## Title: Hwy 63:06/08, S. of Marians Lake to N. of Mariana Lake

Memorandum (or Approval) Date: January 16, 2014 Design Exception Request Date: October 22, 2013 Region: Fort McMurray Approval Status: Approved

# DESIGN STANDARDS/PRACTICE EXCEPTION REQUEST SUMMARY

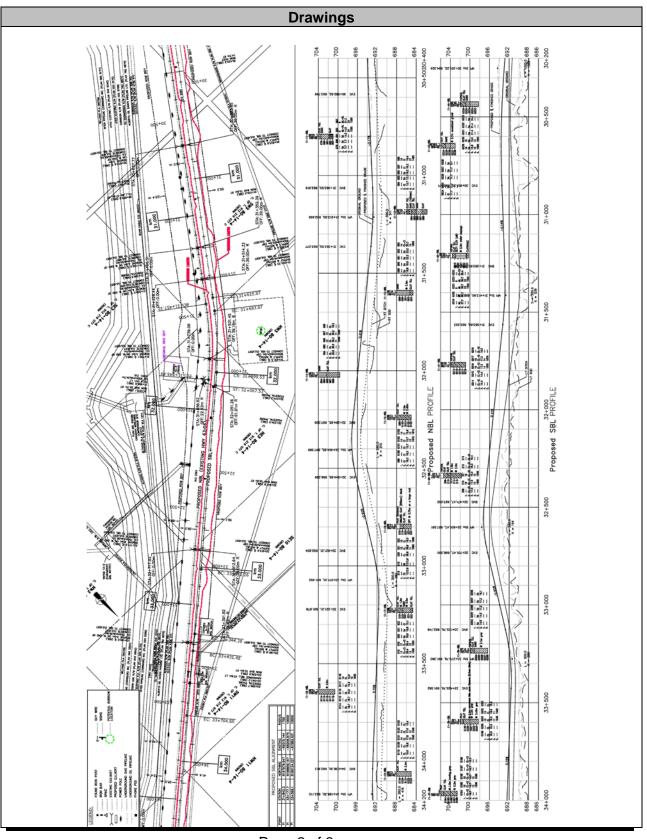
According to AT HGDG – Design Bulletin 70/2010, for new rural divided highway cross-sections, where the land is considered to be lower value, a 55m centerline (CL) spacing is considered desirable and a 40m minimum CL is considered acceptable. The design exception request is for a 25m CL median separation from station 33+011 to 37+176.

There were constraints associated with this project with the presence of a utility corridor on one side and a lake on the other side.

- The economic benefit/cost analysis comparison undertaken by the consultant between a 55m and 25m CL median separation indicates the 25m CL separation is considered more cost effective than the 55m CL median separation.

- According to the consultant, there is a capital cost savings of approximately \$11.58M due to the separation between the existing west pipeline corridor and existing Highway 63 for this section of highway.

- There are no proposed median crossovers and/or intersections within the proposed 25m median separation segment.
- High tension cable barriers (HTCB) although cost effective, will not be installed on the reduced median section at this time. The safety performance will be monitored by the region and HTCB can be installed in the future, if required. This is considered acceptable, as there are other highway sections in the Province which currently have narrower medians and/or are ranked higher in terms of HTCB installation priority.
